Service Bulletin

Bulletin No.: 20-NA-225

Subject: Low Battery Charge After Vehicle Sits for Short Period of Time

Brand:	Model:	Model Year:		VIN:		Engine:	Transmission:
		from	to	from	to		
Chevrolet	Express	2021	2021			L8T	
GMC	Savana

5694188

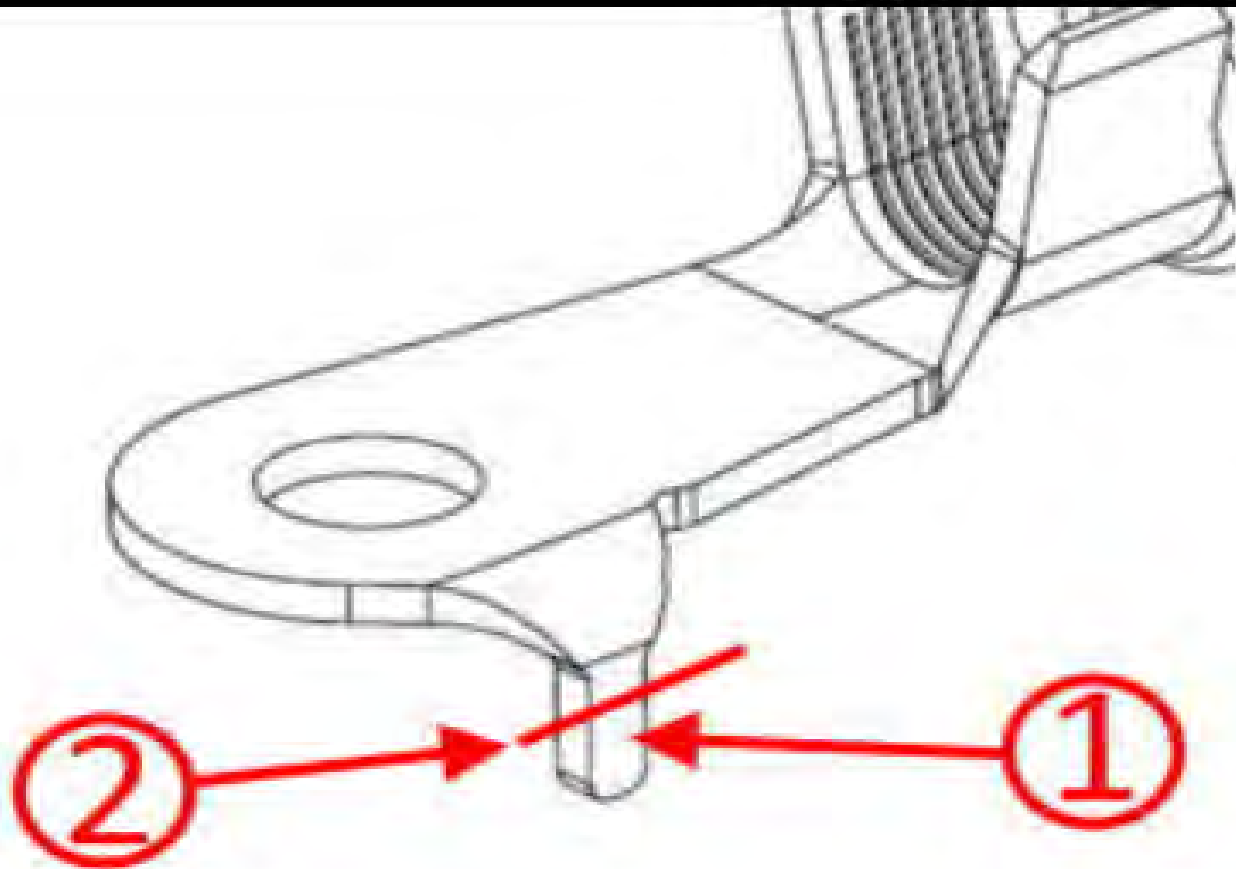
2. Remove the Mega fuse cover (3).
3. Remove the fasteners that secure the pre (2) and post (1) positive cables to the fuse.

4. Starting from the bottom of the anti rotation tab (1), cut half of the tab (straight portion) off (2) as shown in the graphic above.

5693964

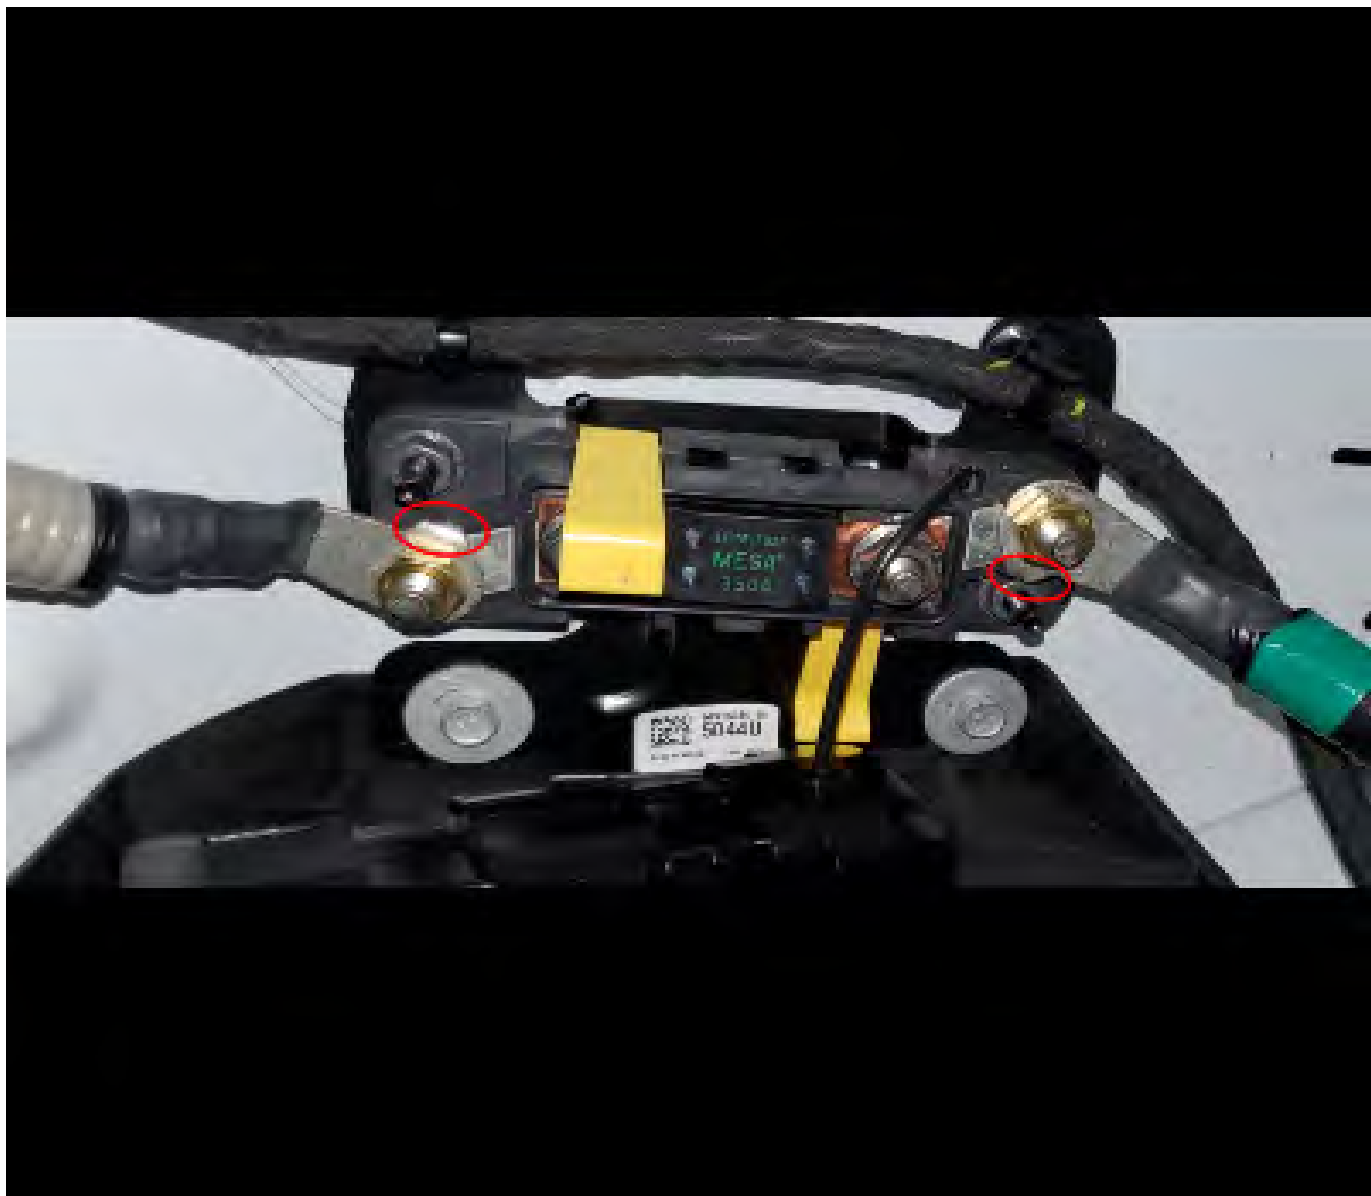
5. Utilizing cutters, cut the tabs from the cables.

Note: Only cut enough of the tab so that it does not contact the stud or the fastener as shown in the graphic above.

Important: DO NOT cut the all the anti rotation tab flush, as shown in the graphic above. Cutting the tab flush may cause the cables to rotate and contact the fasteners or the Mega fuse mounting studs.
